Access Compliance Report Public Rights-of-Way (Curb Ramps)

Main Street: RANCHWOOD_RD Cross Street: IRVINE_BLV Location: SE

ADA ID: RPRK211006113248 Ramp Type: Type 1 - Perpendicular Diagonal Initial Pass/Fail: Fail Overall Compliance: No Severity Score: 15

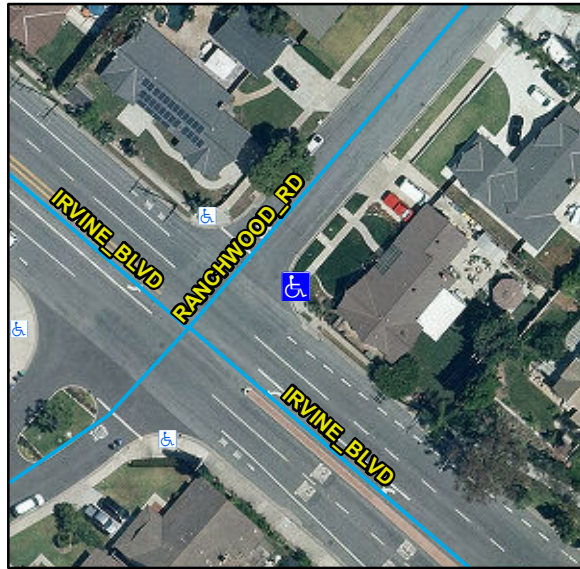
Compliance	Description	Data	Compliance	Description	Data
N/A	Ramp Length (in)	83	N/A	Flare Type LT	
Yes	Ramp Width (in)	48			N/A
No	Ramp Run Slope (%)	9.8	N/A	Flare Slope LT (%)	N/A
Yes	Ramp Cross Slope (%)	1.6	N/A	Flare Traversable LT	N/A
N/A	Landing Present	N/A	N/A	Flare Type RT	
N/A	Landing Length (in)	N/A			N/A
N/A	Landing Width (in)	N/A	N/A	Flare Slope RT (%)	N/A
N/A	Landing Run Slope (%)	N/A	N/A	Flare Traversable RT	N/A
N/A	Landing Cross Slope (%)	N/A	N/A	DWS Provided	N/A
N/A	Landing Movement Obstructed?	N/A	N/A	DWS Contrast	N/A
	Landing Movement Type	N/A	N/A	DWS Length (in)	N/A
N/A	Landing Shared	N/A	N/A	DWS Full Width	N/A
N/A	Clear Space	Yes	N/A	DWS Offset Left (in)	N/A
N/A	Clear Space To Crosswalk (in)	N/A	N/A	DWS Offset Right (in)	N/A
N/A	Marked Crosswalk 1	No	N/A	Marked Crosswalk 2	No
	Crossing 1 Direction	N		Crossing 2 Direction	W
	Marked Crosswalk 1 Width (in)	N/A		Marked Crosswalk 2 Width (in)	N/A

Remove & Replace Curb Ramp With Two New Directional Ramps or Equivalent.

R304.2.2, STD 1115
